## **Working Party on Inland Water Transport**

### **Revision of the Recommendation on electronic chart display and information system for inland navigation (resolution No. 48, revision 3)**

#### **Transmitted by the Government of the Russian Federation**

### Amendment proposals to the revised text of Part D of the Recommendation on electronic chart display and information system for inland navigation (resolution No. 48, revision 3)\*, \*\*

Fig.2: Inland ECDIS equipment, self-sufficient system with connection to radar and AIS (information and navigation mode)

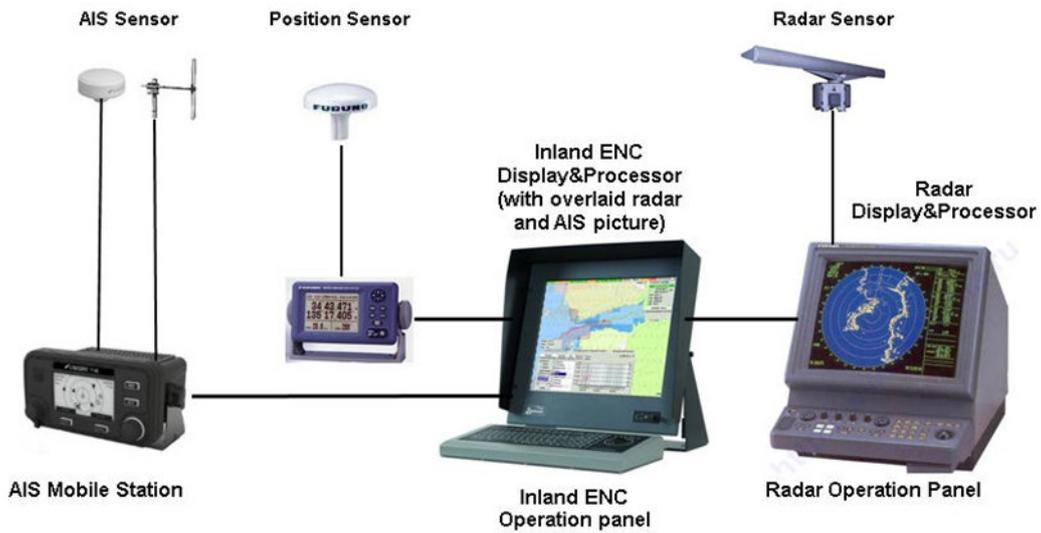
6. It is proposed to modify the images of figures 1 to 4 in section 4B as 3D and to indicate the AIS mobile station (transponder) as an external sensor.

8. Figure 2, Inland ECDIS equipment, parallel installation with connection to radar (system configuration 2)

Fig.3: Inland ECDIS equipment with connection to radar, AIS and shared monitor (information and navigation mode)

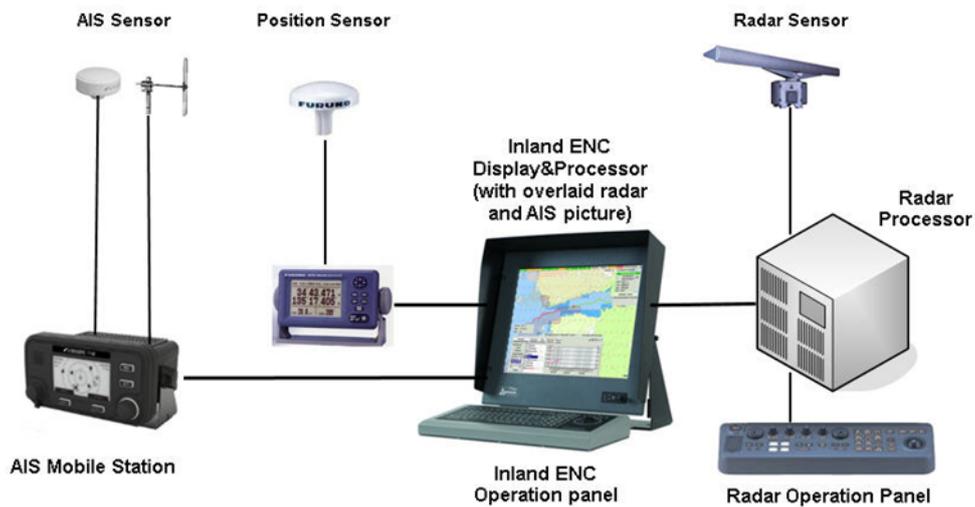
9. Figure 3, Inland ECDIS equipment with connection to radar and shared monitor (system configuration 3)

Fig. 4: Navigational radar equipment with integrated Inland ECDIS functionality  
(information and navigation mode)

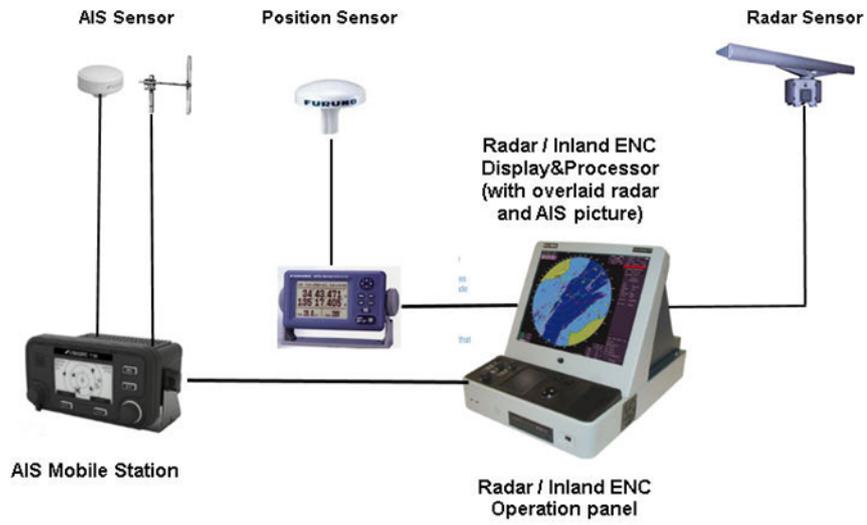
10. Figure 4, Navigational radar equipment with integrated Inland ECDIS functionality  
(system configuration 4)
